11111 JEFFERSON BOULEVARD MIXED-USE PROJECT

Final Environmental Impact Report
State Clearinghouse No. 2020090329

Prepared for
City of Culver City
Culver City Case Nos:
P2021-0025- CP/DOBI/TPM/ZCMA

August 2021

Figure 2.2-1
Machado Road Median Concept

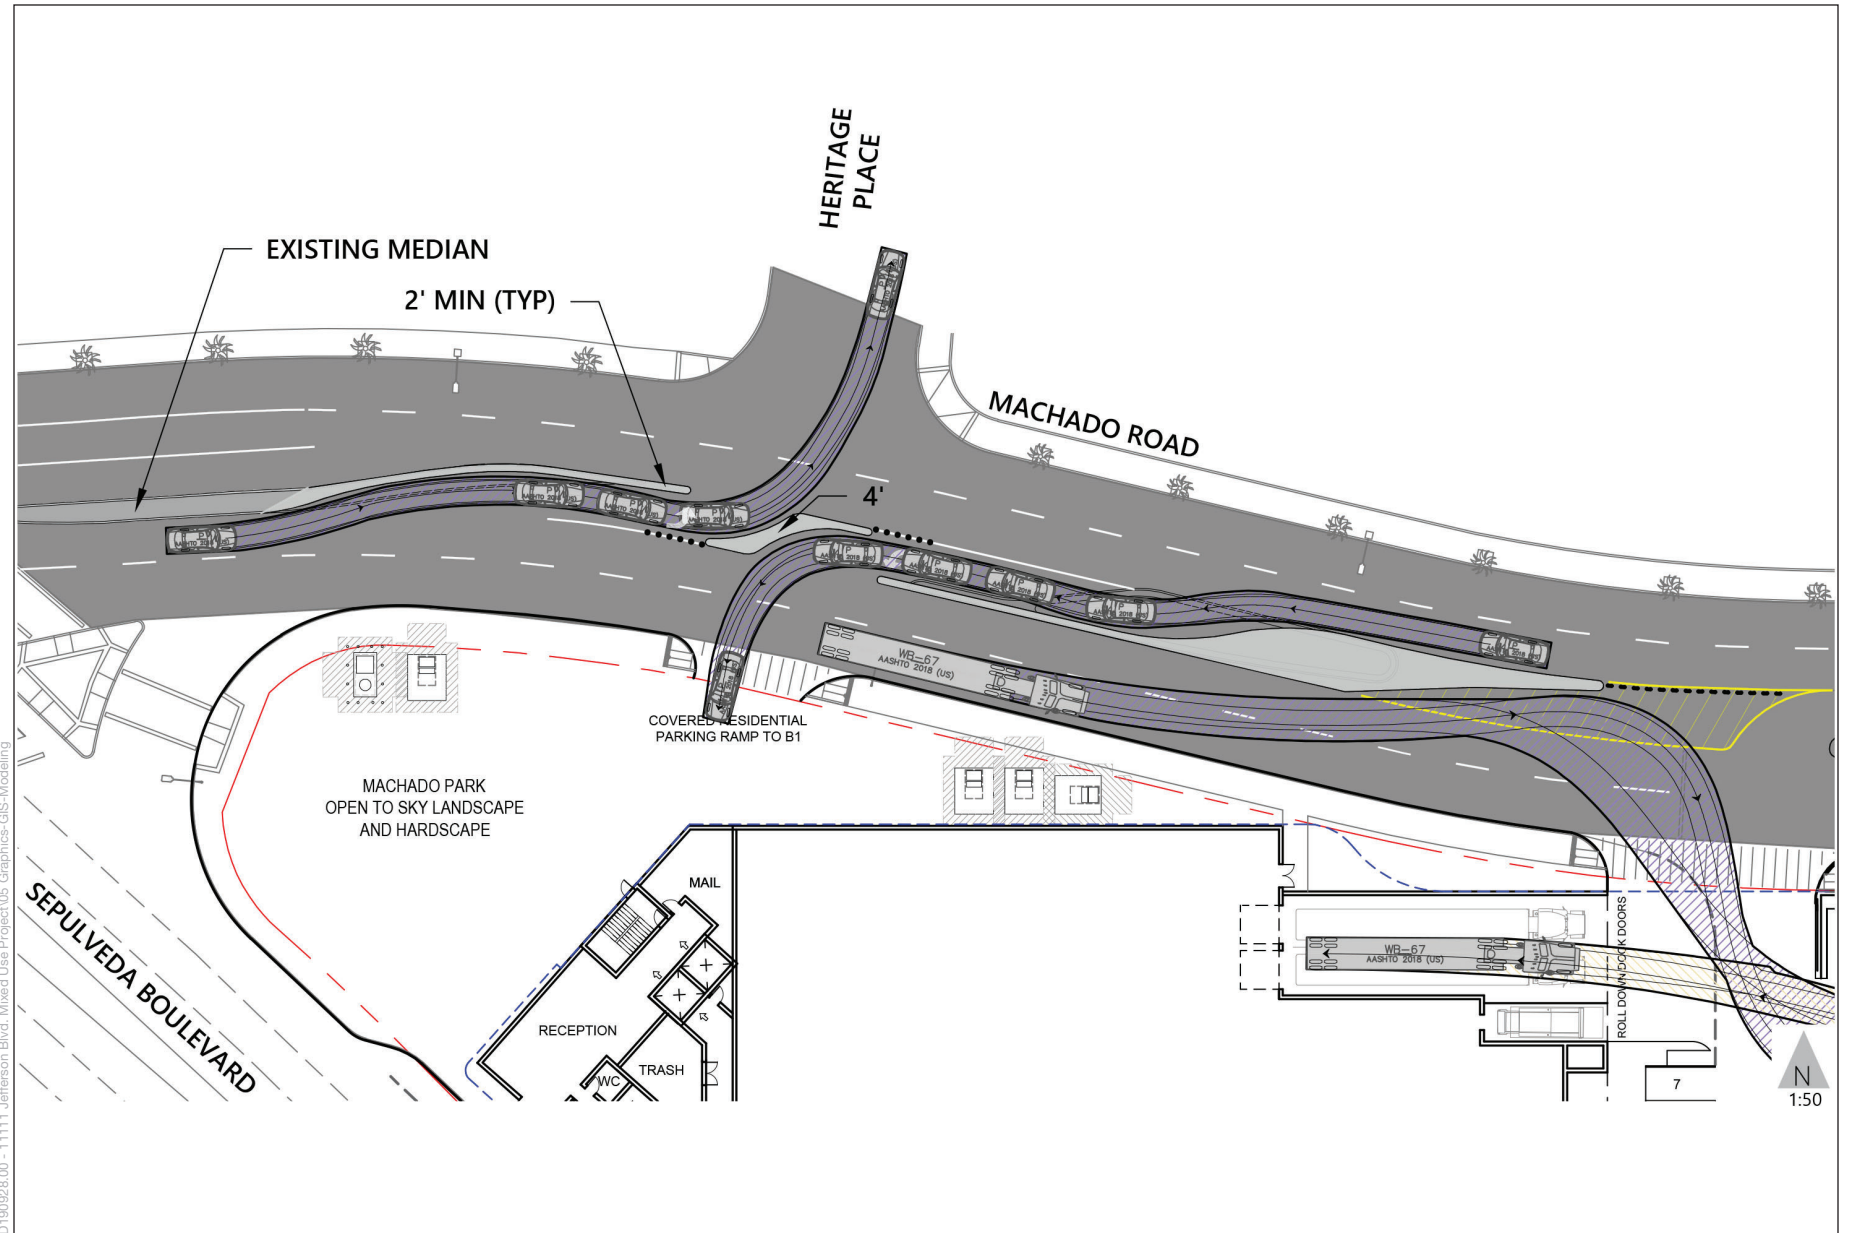
2. Design and fund an [sic] sufficient extension of the raised pedestrian sidewalk and curb at Jefferson and Ballona Lane so that there is only a right turn exit from Ballona Lane onto Jefferson, but no longer permits a right turn entry from Jefferson onto Ballona Lane (but which can still be traversed by emergency trucks). With the proposed redesign of #1 above, this will go a long way to eliminate/greatly disincentivize (a) cut through traffic into our community by vehicles wanting to avoid the Jefferson/Machado intersection and access either the Project's residential parking entrance or northbound travel on Sepulveda, and (b) parking on the private streets in our community that our HOA pay to maintain by the retail/commercial invitees of the Project or guests of the Project's residents

Nevertheless, in response to the concerns raised in the letter, these comments were discussed with City staff and Richard Ochoa, representative of The Classics at Heritage Park Homeowners Association (HOA), during a meeting held and recorded at 4:00 P.M. on June 16, 2021. As a result of this meeting, it was agreed that the Project would construct a raised median on Machado Road in a manner to preserve left-turn access from eastbound Machado Road into the Heritage Park neighborhood and provide left-turn access from westbound Machado Road into the Project Site for residents, while physically separating the opposing left-turn pockets and physically prohibiting through and left-turning movements from either Heritage Place or the Project's residential driveway at Machado Road. **Figure 2.2-1, Machado Road Median Concept**, illustrates the concept for this median island. Vehicles exiting the Project residential driveway would be required to turn right onto eastbound Machado Road. Other measures such as signage and vertical delineation would also be introduced along Machado Road to reinforce turn prohibitions, including U-turn prohibitions on Machado Road. The Project would also install a raised curb extension at the intersection of Ballona Lane and Jefferson Boulevard that would prohibit any entry except for emergency vehicles into the Heritage Park neighborhood from Jefferson Boulevard, and only allow for eastbound right-turns from Ballona Lane out of the neighborhood. **Figure 2.2-2, Ballona Lane Access Restriction Concept**, illustrates the concept for this closure. The exact dimensions and design of these features at the entrances to the Heritage Place community would be determined

during the preparation of construction plans and will be approved by the City. These changes and refinements to access provisions are now reflected in Chapter 2, Project Description, of the Draft EIR, as shown in Section 3, Revisions, Clarifications, and Corrections to the Draft EIR, of this Final EIR. These changes do not alter the impact findings in the Draft EIR or result in any new or substantially more severe significant impacts, as the revised Project driveways would also be designed to comply with City standards, provide adequate sight distance, and protect safety for all roadway users.
